PET SUITES JSP 19-18

Consideration at the request of Hogan Real Estate for Preliminary Site Plan and Storm Water Management Plan approval for a pet boarding facility. The subject property is approximately 2.48 acres and is located on the south side of Grand River Avenue, east of Beck Road (Section 16). The vacant parcel is zoned I-1, Light Industrial. The applicant is proposing to construct a 10,980 square foot building with a fenced outdoor recreation area for the boarding of cats and dogs.

PLANNING REVIEW

Planning Review

Figure 1. City of Novi Regulated Wetland & Woodland Map (approximate project boundary shown in red). Regulated Woodland areas are shown in green and Regulated Wetland areas are shown in blue.

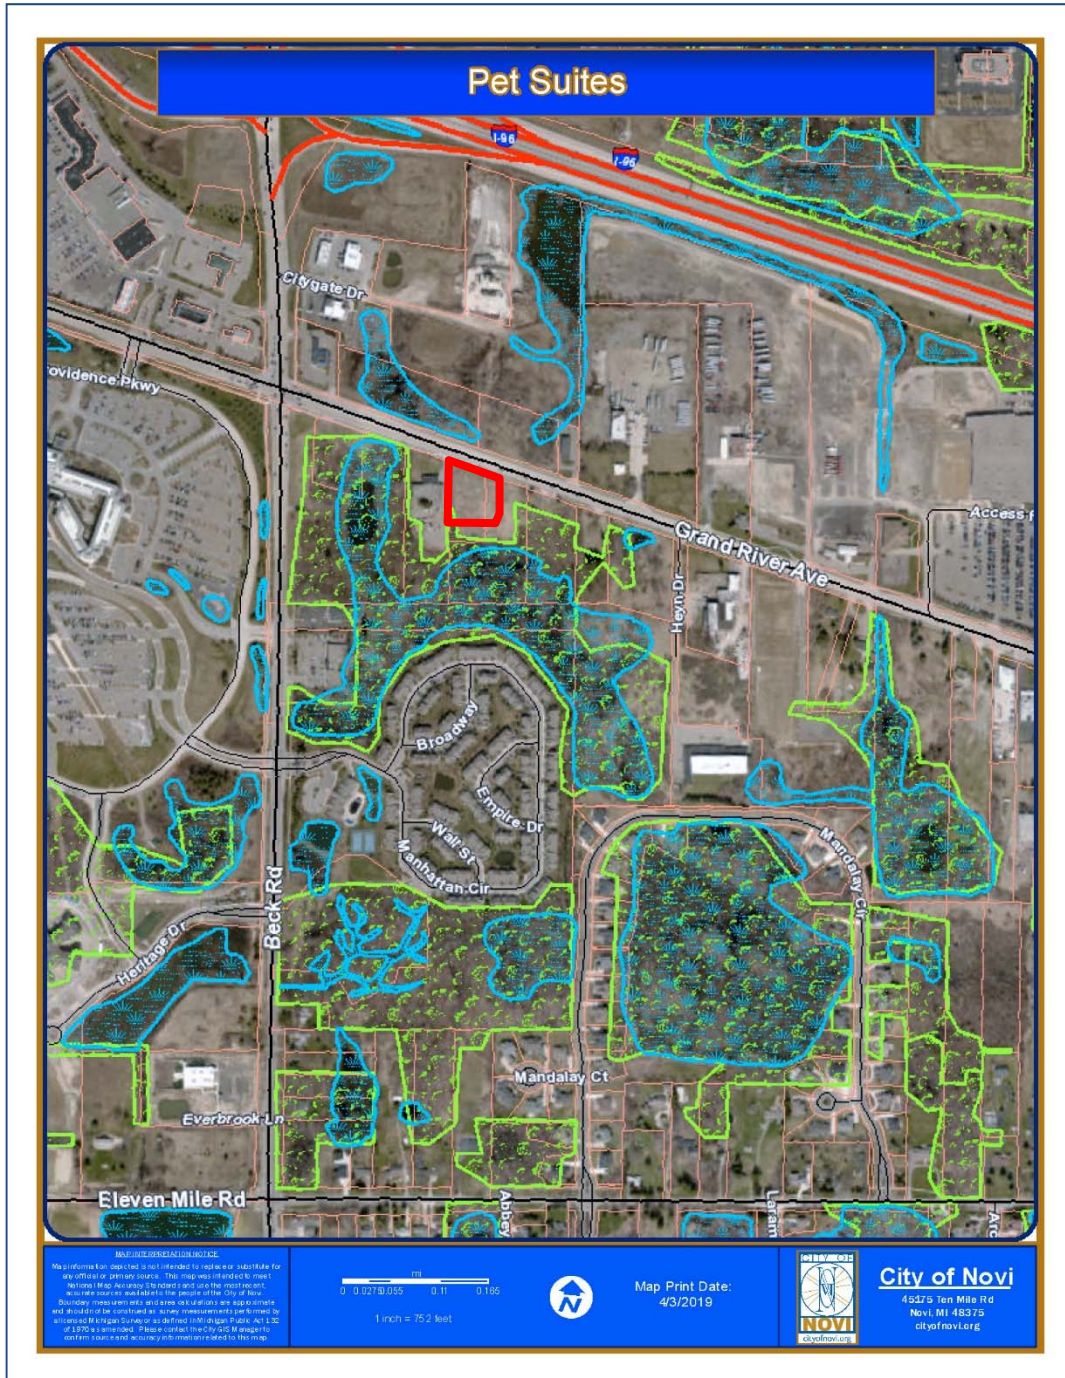
Based on our review of the Plan, Novi aerial photos, Novi GIS, City of Novi Official Wetlands and Woodlands Map (see Figure 1), and on-site evaluation, this proposed project site contains areas indicated as Regulated Woodlands as well as Regulated Wetlands. The area mapped as regulated woodland is located south of the proposed limits of disturbance for the project. Impacts to regulated woodlands are not proposed.

ECT has reviewed the City of Novi Official Woodlands Map and completed an onsite Woodland Evaluation on May 8, 2019. ECT's in-office review of available materials included the City of Novi Regulated Woodland map and other available mapping. As noted above, area located on the southern portion of the property (south of the proposed limits of disturbance) is mapped as City of Novi Regulated Woodlands on the official City of Novi Regulated Wetland and Watercourse Map (see Figure 1). The area included within the project's limits of disturbance primarily consists of open, previously cleared land. Areas of wetland, 25-foot wetland setback, and regulated woodland are located south of the proposed limits of disturbance.
